# Vien An Buddhist Temple, Preliminary Plan No. 120160310

#### PRELIMINARY PLAN RECOMMENDATION AND CONDITIONS

Figure 2: Preliminary Plan (Attachment 2)

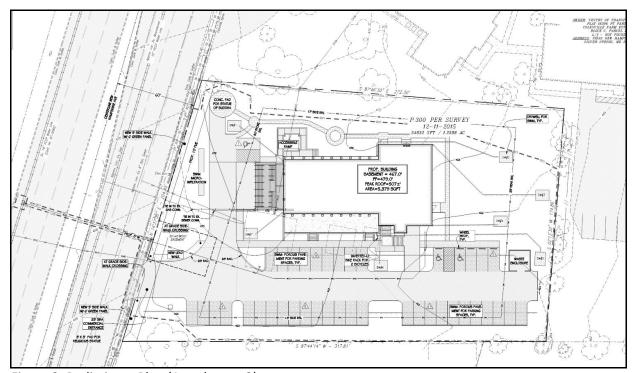
- 5. Prior to Certified Preliminary Plan the Applicant must revise the drawing to show:
  - a. Wheel stops for all parking spaces at grade with adjacent sidewalks; and

- b. The correct number of parking spaces and labels.
- 6. The Applicant must provide 2 bicycle parking spaces (1 inverted-U bike racks as shown on the Preliminary Plan.
